SHOP DRAWING REVIEW

Project: BR # 162 VT RTE 73 & 100 ROCHESTER, VT
Drawing: BR # 16 CLOSURE POUR REINF.

Date	Drawn	Chkd.	JOB No.	Dwg. No.
05/07/2014	MAD	JOE	33505211	BR16-01

BRIDGE #16 P.C. DECK PLAN

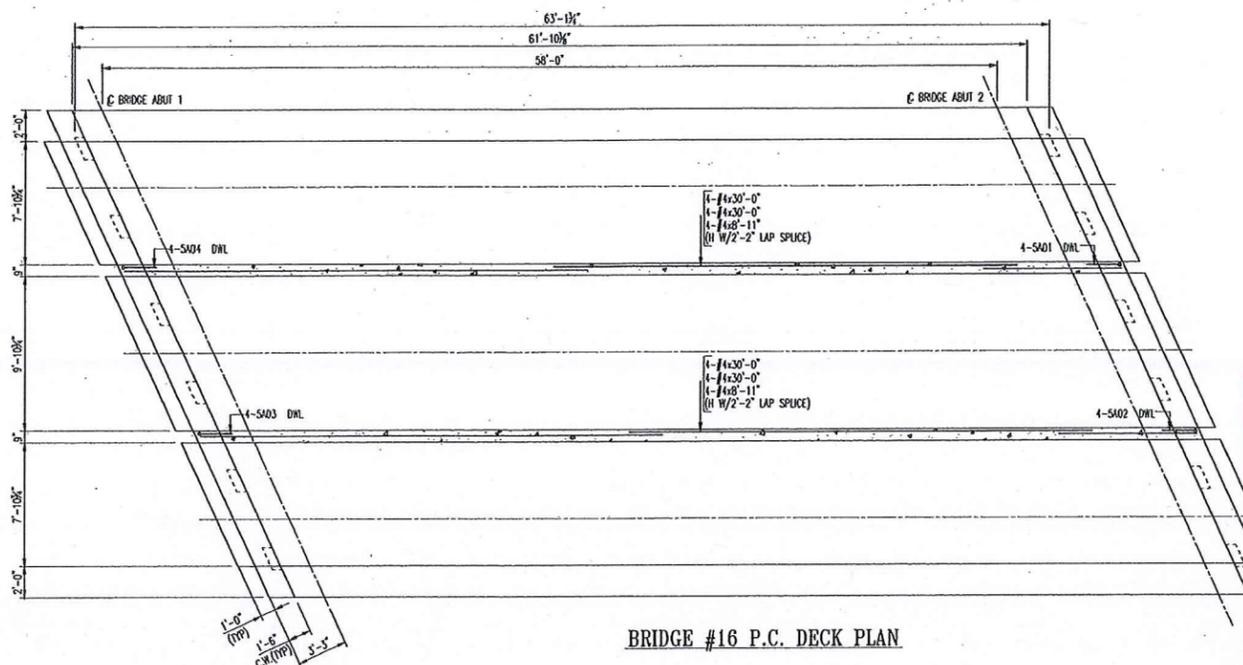
Confirm Lengths
